UNITED STATES PATENT AND TRADEMARK OFFICE

APPLICATION NO.	FILING DATE	FIRST NAMED INVENTOR	ATTORNEY DOCKET NO.	CONFIRMATION NO.
10/567,173	02/03/2006	Joseph M. Amato	US03 0199 US2	9635
65913	7590	10/28/2008		
NXP, B.V. NXP INTELLECTUAL PROPERTY DEPARTMENT M/S41-SJ 1109 MCKAY DRIVE SAN JOSE, CA 95131			EXAMINER LEE, HSIEN MING	
			ART UNIT 2823	PAPER NUMBER
			NOTIFICATION DATE 10/28/2008	DELIVERY MODE ELECTRONIC

Office Action Summary	Application No.	Applicant(s)	
	10/567,173	AMATO, JOSEPH M.	
	Examiner	Art Unit	
	Hsien-ming Lee	2823

DETAILED ACTION

FIG. 5A

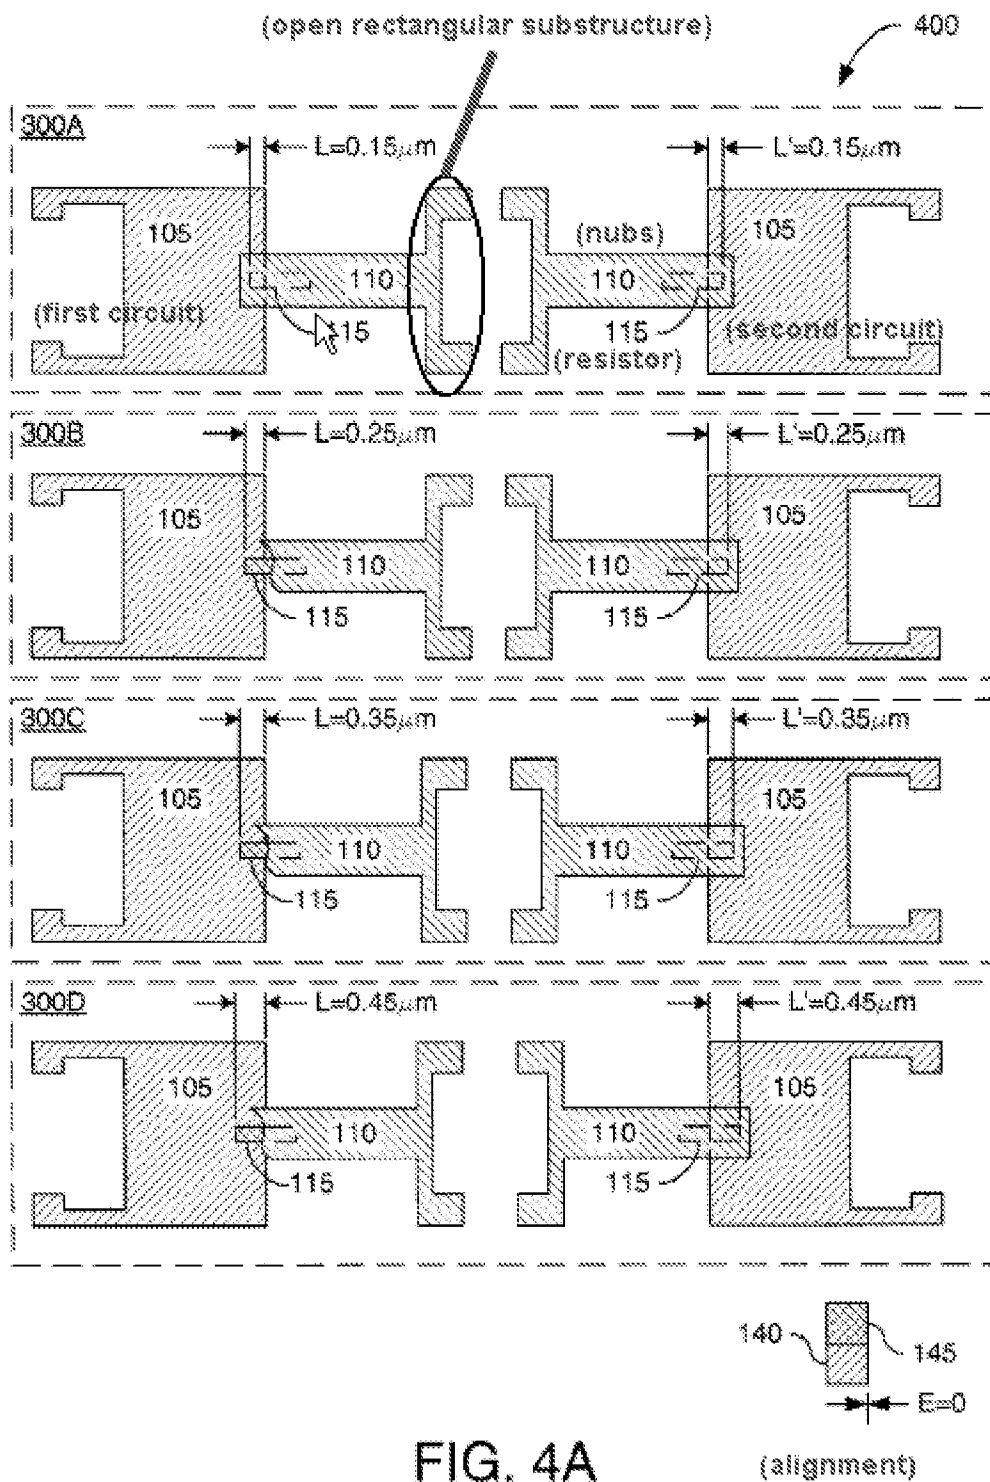
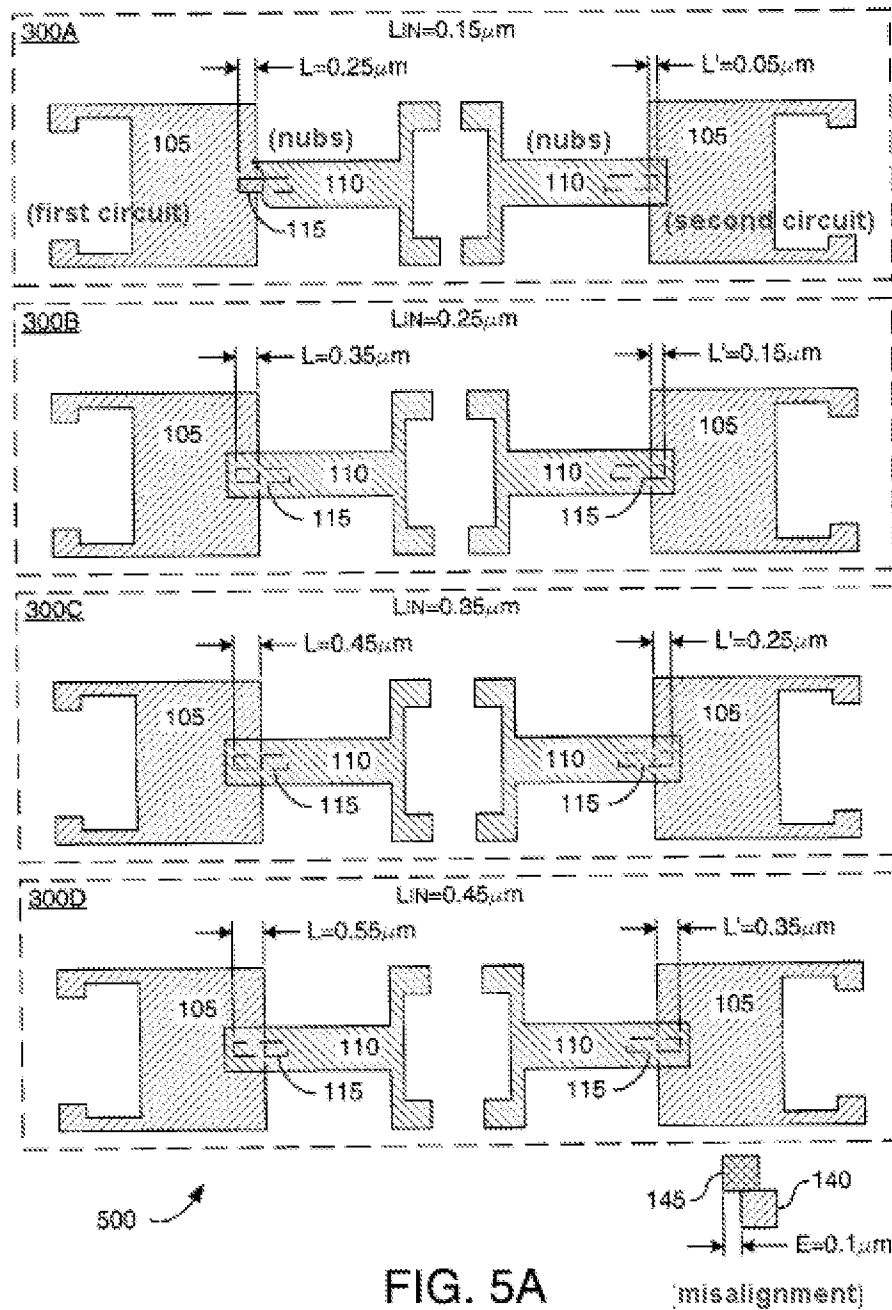
In re claim 1, Look et al, in Figs. 4A, 5A and corresponding text, teach a method for identifying misalignments in an overlapping region of a stitched circuit in an integrated circuit fabrication process, comprising:

- creating a first circuit 105 (the one the left) using a reference mask, wherein first circuit 105 includes a first part of an offset dependent resistor structure 115 in the overlapping region (Fig.4A);

- creating a second circuit 105 (the one on the right) using a secondary mask, wherein the second circuit 105 includes a second part of the offset dependent resistor structure 115 in the overlapping region, wherein the offset dependent resistor structure 115 includes a plurality of nubs 110 that interconnect the first part and the second part of the offset dependent resistor structure 115 (Fig.4A);
- measuring a resistance across the offset dependent resistor structure (paragraph [0045]); and
- determining an amount of misalignment based on the measured resistance (paragraphs [0043], [0045], [0055], [0056]).

In re claim 14, Look et al. teach an offset dependent resistor structure for identifying a misalignment in an overlapping region of a stitched portion of an integrated circuit, comprising:

- * a first part of an offset dependent resistor structure 115 (i.e. the one on the left) created in the overlapping region using a reference mask (Figs. 4A and 5A);
- * a second part of the offset dependent resistor structure 115 (i.e. the one on the right) superimposed on the first part in the overlapping region using a secondary mask; and a plurality of nubs 110 that interconnect the first part and the second part of the offset dependent resistor structure 115 to form a single electrical pathway (Figs. 4A and 5A), wherein the resistance of the single electrical pathway is dependent upon the length of the nubs 110 that interconnect the first part and the second part of the offset dependent resistor structure 115 (see Fig.4B and 5B).

In re claim 19, Look et al., in Figs. 4A and 5A and corresponding text, a system for measuring misalignments in an overlapping region of a stitched portion of an integrated circuit, comprise:

- * an offset dependent resistor structure 115, including: a first part 105 (the one on the left) created in the overlapping region using a reference mask, a second part 105 (the one on the right) superimposed on the first part in the overlapping region and created using a secondary mask; and
- * a plurality of nubs 110 oriented in a first uniform direction that interconnect the first part and the second part to form a single electrical pathway, wherein the resistance

of the single electrical pathway is dependent upon the length of the hubs 110 (see Figs. 4B and 5B) that interconnect the first part and the second part, and a system for measuring the resistance across the single electrical pathway (paragraphs [0043], [0045], [0055], [0056].

FIG. 7

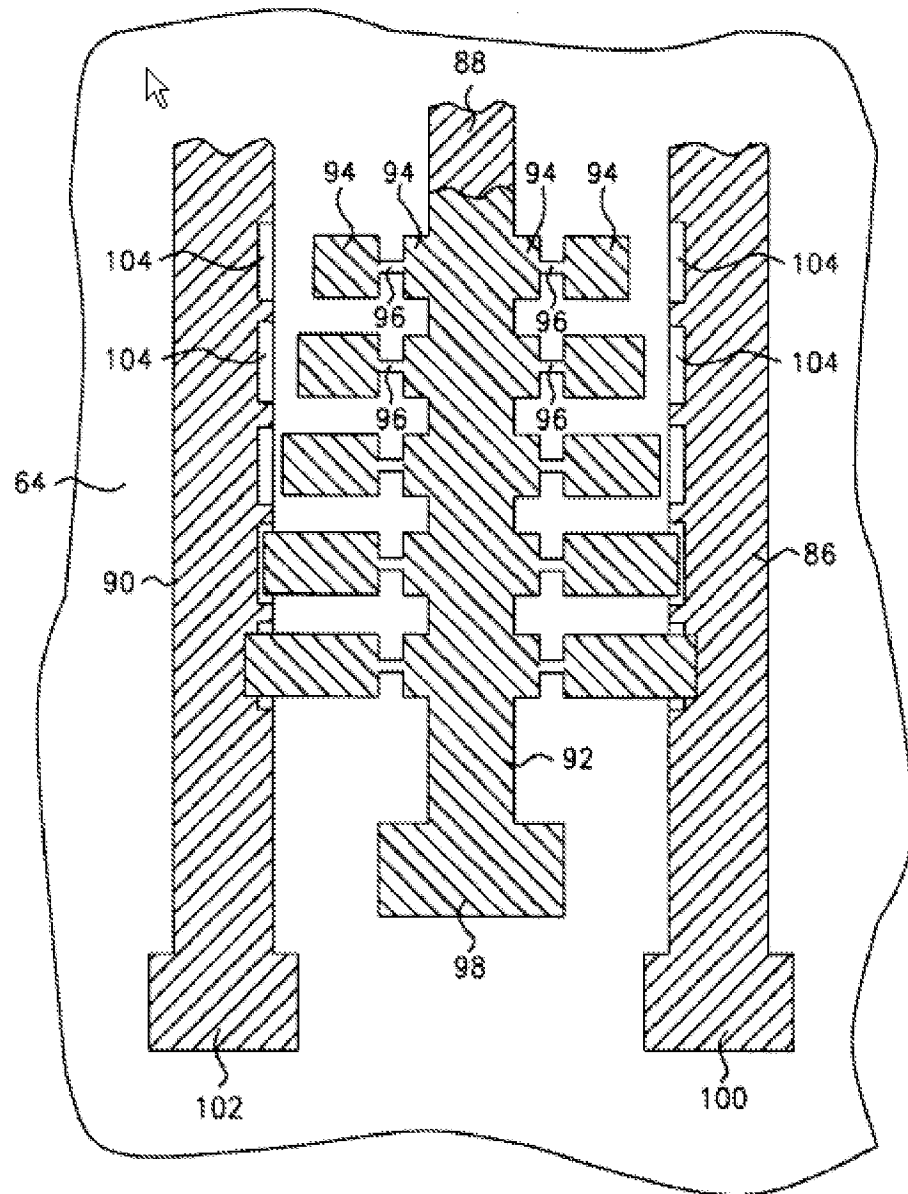
In re claim 1, Wu et al, in Fig. 7 and corresponding text, teach a method for identifying misalignments in an overlapping region of a stitched circuit in an integrated circuit fabrication process, comprising:

- creating a first circuit 90 using a reference mask, wherein first circuit 90 includes a first part of an offset dependent resistor structure 96 in the overlapping region;
- creating a second circuit 86 using a secondary mask, wherein the second circuit 86 includes a second part of the offset dependent resistor structure 96 in the overlapping region, wherein the offset dependent resistor structure 96 includes a plurality of nubs 96 that interconnect the first part and the second part of the offset dependent resistor structure 96;
- measuring a resistance across the offset dependent resistor structure (col. 6, lines 33-57); and

- determining an amount of misalignment based on the measured resistance (col. 6, line 65 through col. 7, line 2).

In re claim 14, Wu et al., in Fig.7 and corresponding text, teach an offset dependent resistor structure for identifying a misalignment in an overlapping region of a stitched portion of an integrated circuit, comprising:

- * a first part of an offset dependent resistor structure (94/96 on the left side of 92) created in the overlapping region using a reference mask;
- * a second part of the offset dependent resistor structure (94/96 on the right side of 92) superimposed on the first part in the overlapping region using a secondary mask; and a plurality of nubs 96 that interconnect the first part and the second part of the offset dependent resistor structure 94/94 to form a single electrical pathway, wherein the resistance of the single electrical pathway is dependent upon the length of the nubs 96 that interconnect the first part and the second part of the offset dependent resistor structure 94/96.

In re claim 15, Wu et al., in Fig.7 and corresponding text, teach comprising a pair of test pads 100 and 102 at ends of the single electrical pathway.

In re claim 19, Wu et al., in Fig. 7 and corresponding text, a system for measuring misalignments in an overlapping region of a stitched portion of an integrated circuit, comprise:

- * an offset dependent resistor structure, including: a first part 102 created in the overlapping region using a reference mask, a second part 100 superimposed on the first part in the overlapping region and created using a secondary mask; and
- * a plurality of nubs 96 oriented in a first uniform direction that interconnect the first part 102 and the second part 100 to form a single electrical pathway, wherein the resistance of the single electrical pathway is dependent upon the length of the hubs 96 that interconnect the first part 102 and the second part 100, and a system for measuring the resistance across the single electrical pathway (col. 6, lines 33-57 and col. 6, line 65 through col. 7, line 2).

In re claim 20, Wu et al., in Fig.7 and corresponding text, teach that the system for measuring the resistance comprises a pair of test pads 100 and 102 at ends of the single electrical pathway and a pair of probes.
